Feedback for DeskBeam POC Schematic:

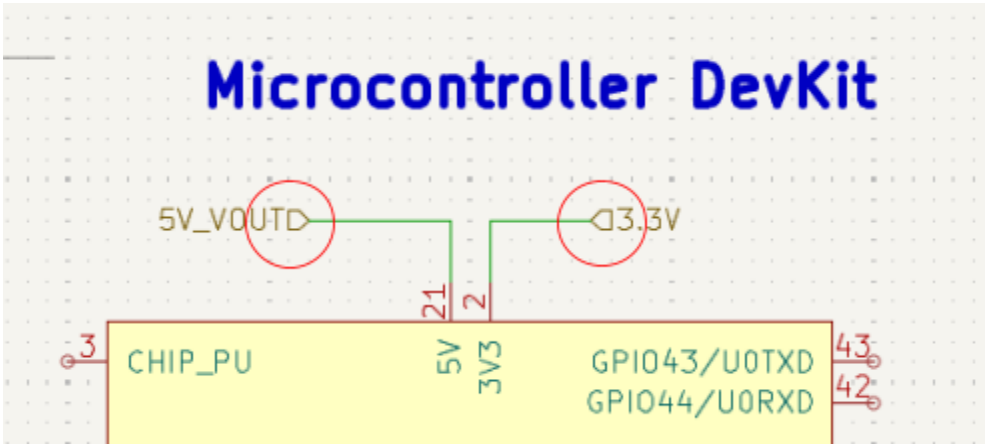
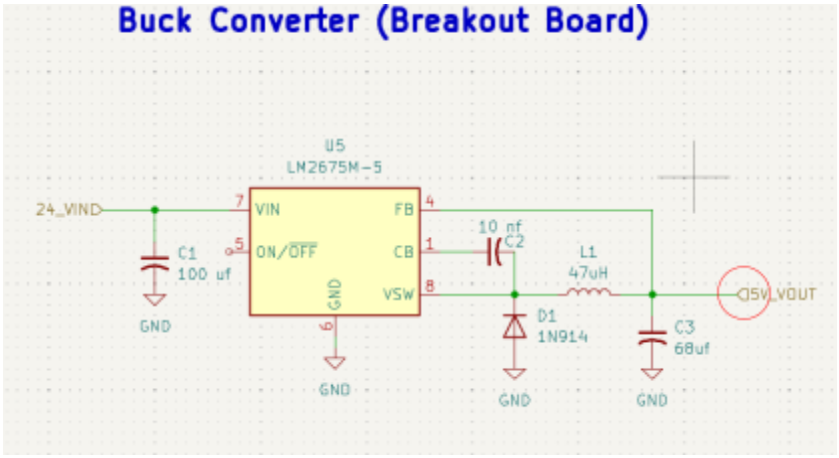
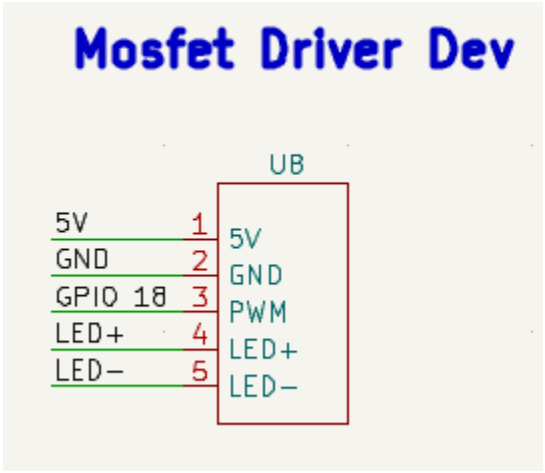
- Extremely neat schematic
    - Easy to trace and understand where the connections are being made
    - Used many labels and not direct lines for clarity
    - Notes in the boxes are a nice touch
- 5V and 3.3V have input symbols instead of output symbols
    -

- Is this on purpose? The 5V input can power the ESP32, but the 3.3V input at the same time can damage it
- In the buck converter, the (assumed) output of 5V_VOUT has the input symbol
    -

- There's a mention of an LED in multiple places. Is it included in the POC?
- From the Push Buttons, they go into GPIO 21 and GPIO 22, but there's no connection to them on the ESP32

- Is this 5V input the same as the 5V_VOUT on the buck converter?
-

- Might need pullup resistors for buttons and SCL SDA GPIO pins
- Overall AMAZING work
